CIRCUIT DESCRIPTION

CD-1C605-01
ISSUE 28
APPENDIX 3D
DWG ISSUE 5D
DISTR CODE 3N21

COMMON SYSTEMS
VOICE FREQUENCY TRANSMISSION
SWITCHED MAINTENANCE ACCESS SYSTEM
NO. 3A, 3B, AND 3C
TYPE 3 MAINTENANCE CONNECTOR

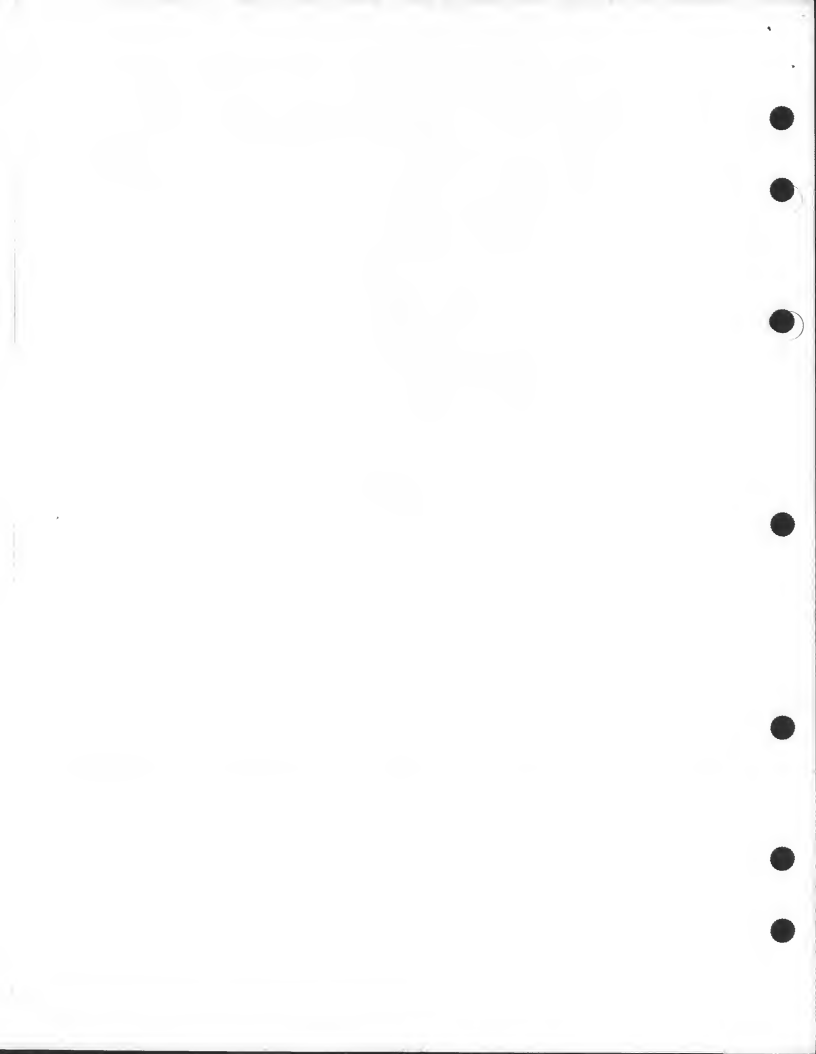
B. Changes in Apparatus (Components)

B.1 Superseded

CR 1, 2, 3, 9 Diodes,
533C Diodes,
App Fig. 2

Superseded By

CR 1, 2, 3, 9 Diodes,
533F Diodes,
App Fig. 2

D.1 Drawing rating is changed to Mfr Disc.
